1. Position of the jib tack

Two F18 builders have approached class management with the request to change the class rules so that the tack of the jib can be set below the apex of the forestay bridle. As per the class rule C.10.3(b) this is currently not possible:

Diagram 1: illustration of force F2 exercised by bridles on bridle attachment points

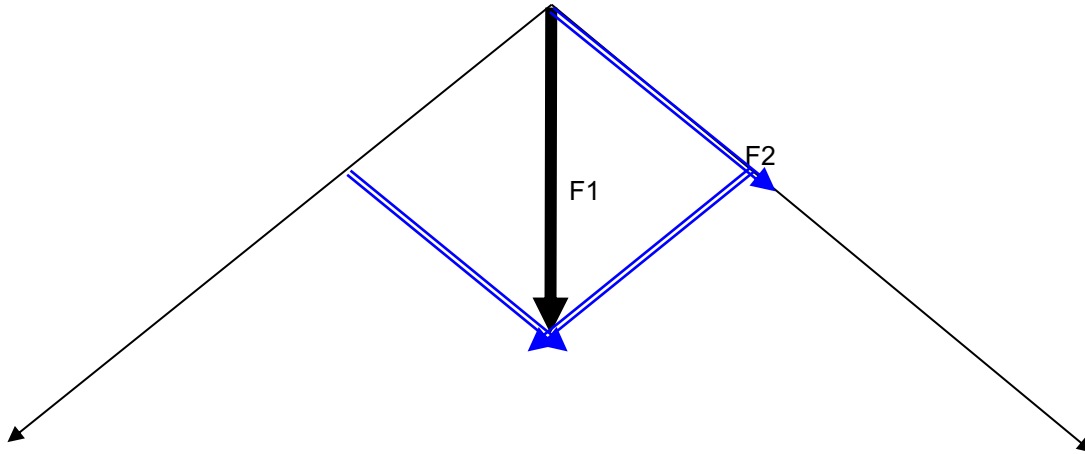
- Lowering the apex increases the loads exercised by the bridles on the hull attachment points. This causes hull construction challenges and reduces longevity of the hulls.

- By allowing the jib tack to be set below the apex of the forestay, it will be possible:

- to lower the jib tack without further increasing the loads on the bridle attachment points. The jib tack will be set on the bowsprit (as on the Tornado)
- for builders to redeploy material to other parts of the hulls, increasing stiffness and longevity
